BID
ADDENDUM NO. 3
TO
CONTRACT DOCUMENTS
AND
TECHNICAL SPECIFICATIONS
FOR
2019 BOND REFERENDUM
CAPITAL IMPROVEMENTS
AT
MAMARONECK HIGH SCHOOL
PHASE 2
NYSED #66-07-01-03-0-001-039
BID # 20/21 – MUFSD-00

Mamaroneck Union Free School District
1000 West Boston Post Road
Mamaroneck, NY 10543

LAN Job #4.1092.72.06
January 7, 2022

1 P2.81 1/4" = 1'-0" BOILER ROOM - WORK AREA 'H' NORTH

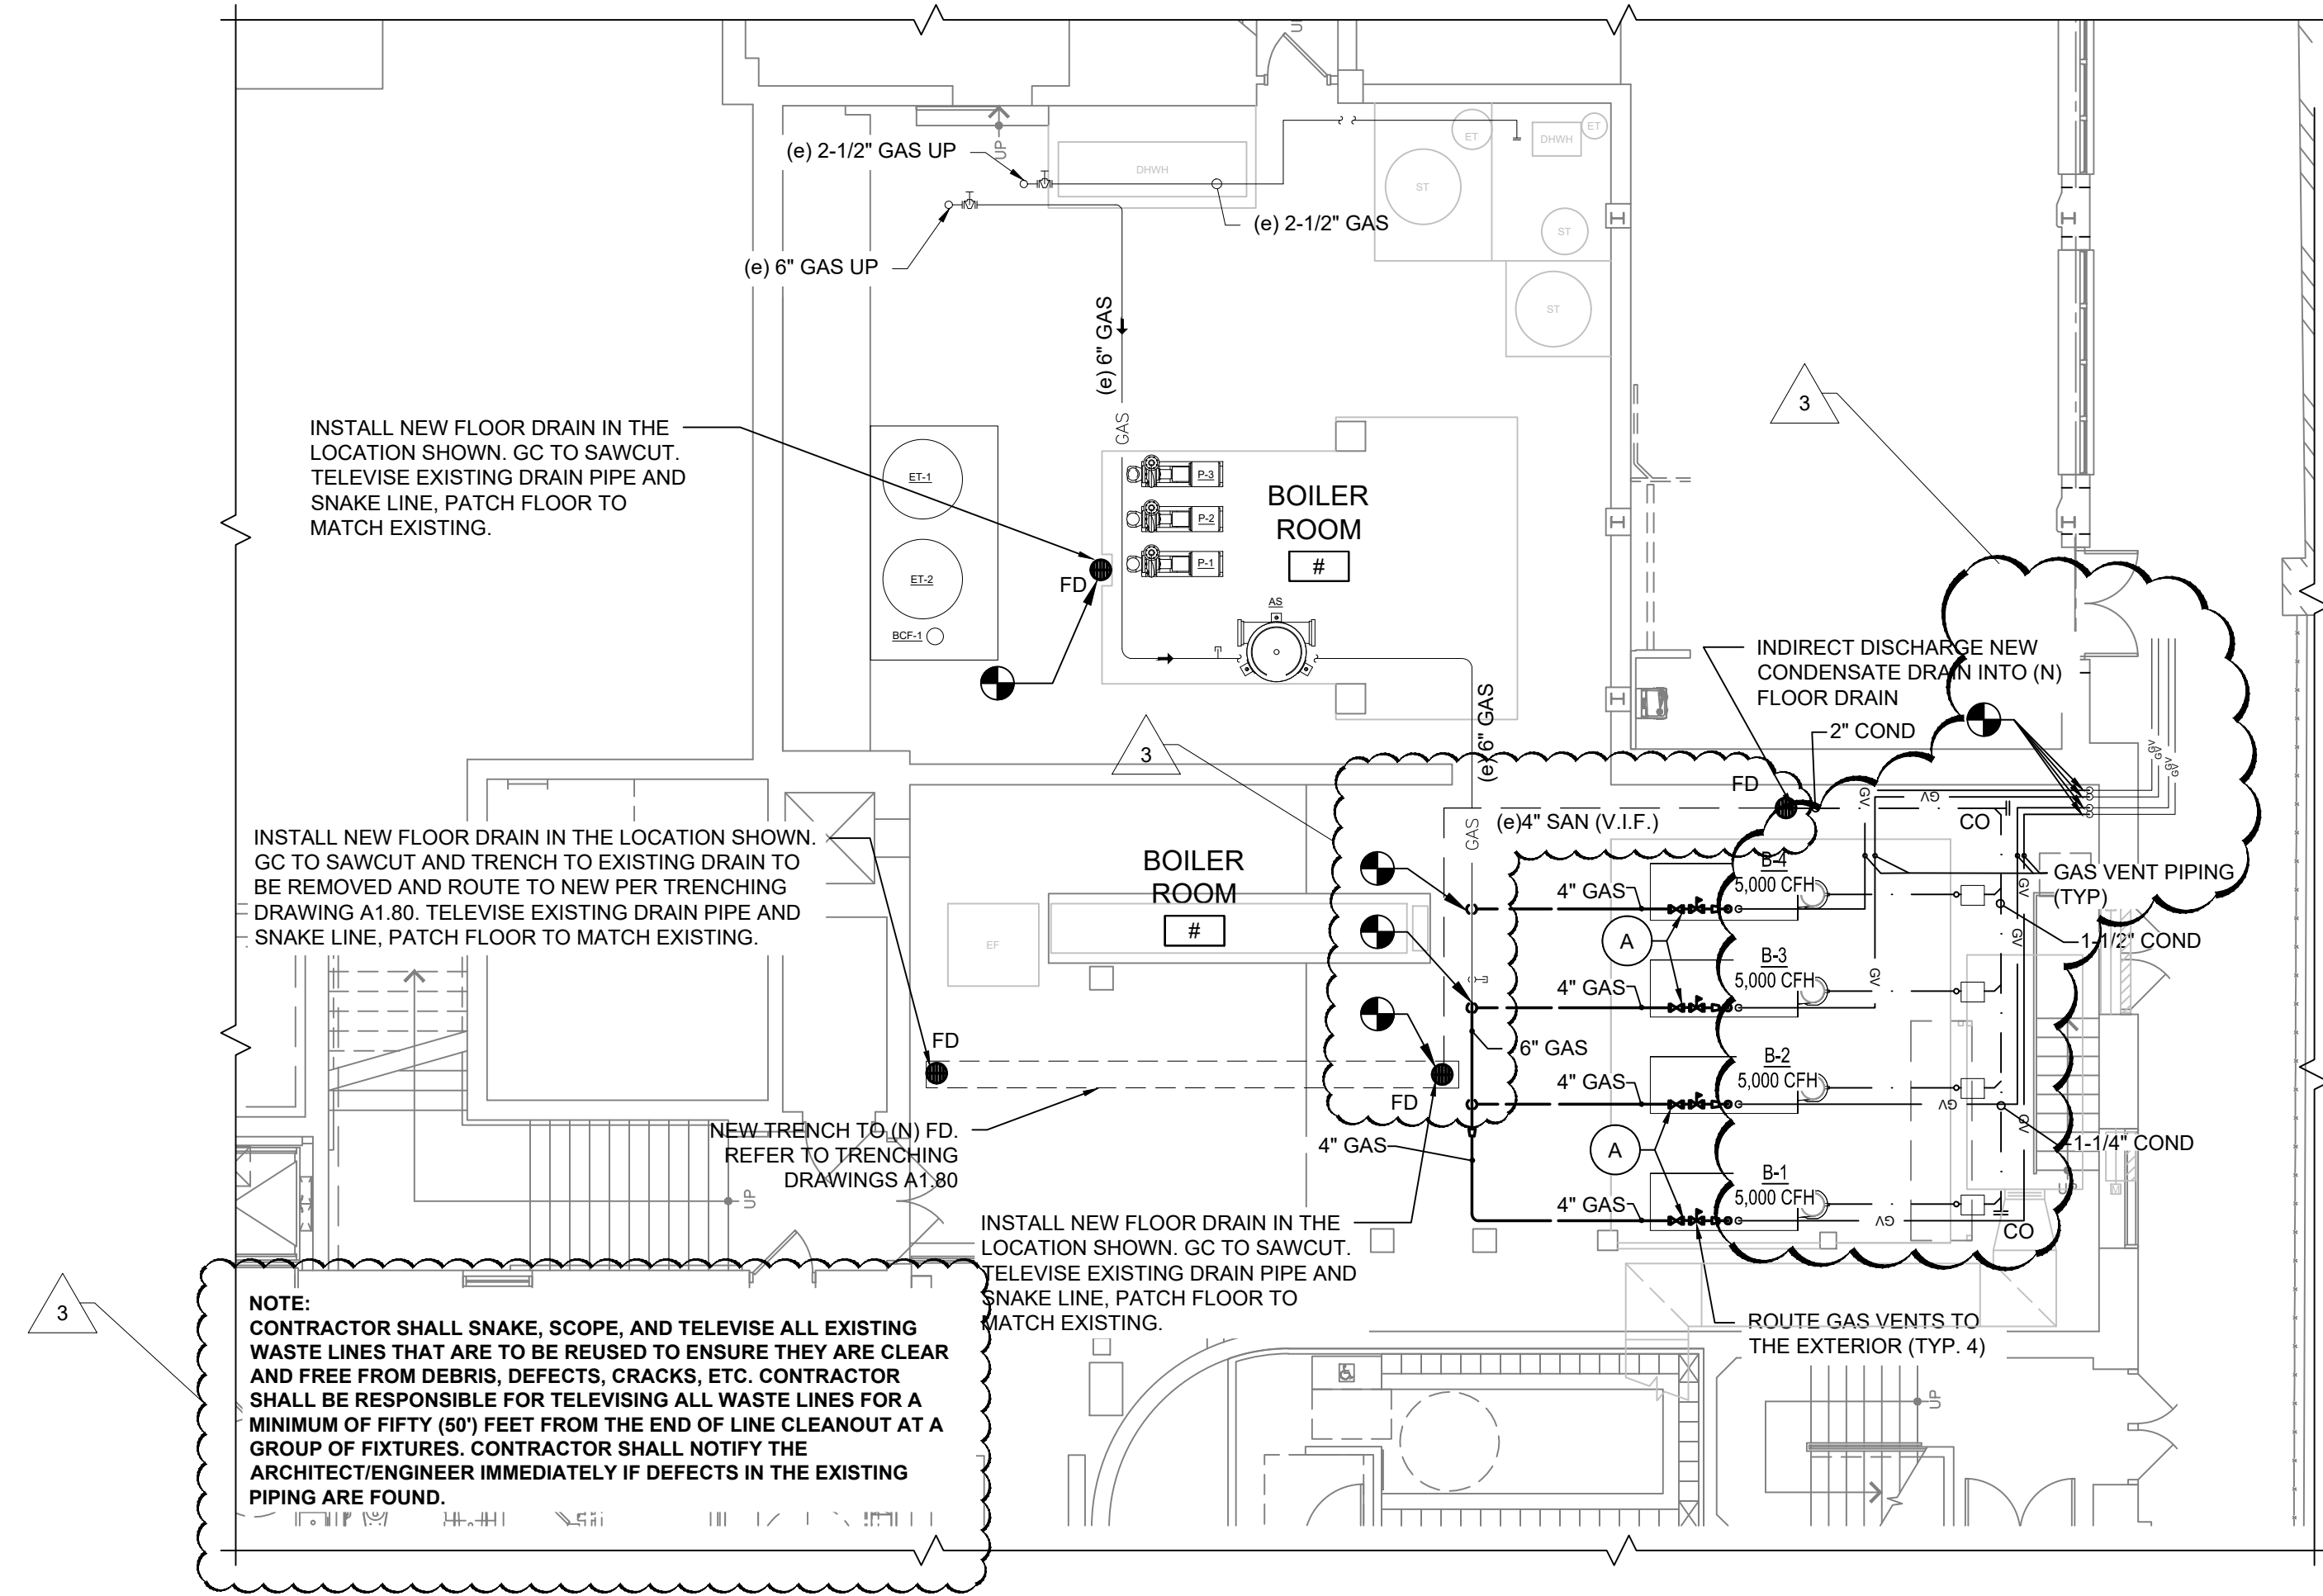
| 12 | <p>Question: Plumbing Contract; Demo of existing gas vent piping & routing new gas piping vents to the exterior in the Palmer Lower Level Boiler Room. Please clarify on drawing where the existing gas vents are & where new gas vent to be routed to the exterior of the building.</p> <p>Response: Existing and proposed Gas Venting shown on P2.81</p> |
| 13 | <p>Question: Plumbing Contract; Drawing P2.81 shows GC to trench and saw cut slab for installation of new floor drains and piping by PC, drawing does not show existing sanitary piping that PC would be connecting new floor drains to. Please clarify.</p> <p>Response: Note added "CONTRACTOR SHALL SNAKE, SCOPE, AND TELEVIEW ALL EXISTING WASTE LINES THAT ARE TO BE REUSED TO ENSURE THEY ARE CLEAR AND FREE FROM DEBRIS, DEFECTS, CRACKS, ETC. CONTRACTOR SHALL BE RESPONSIBLE FOR TELEVIEWING ALL WASTE LINES FOR A MINIMUM OF FIFTY (50') FEET FROM THE END OF LINE CLEANOUT AT A GROUP OF FIXTURES. CONTRACTOR SHALL NOTIFY THE ARCHITECT/ENGINEER IMMEDIATELY IF DEFECTS IN THE EXISTING PIPING ARE FOUND." to P2.81. There are no known drawings that show the exact location of the sanitary line between the floor drains. P.C. to verify in the field.</p> |
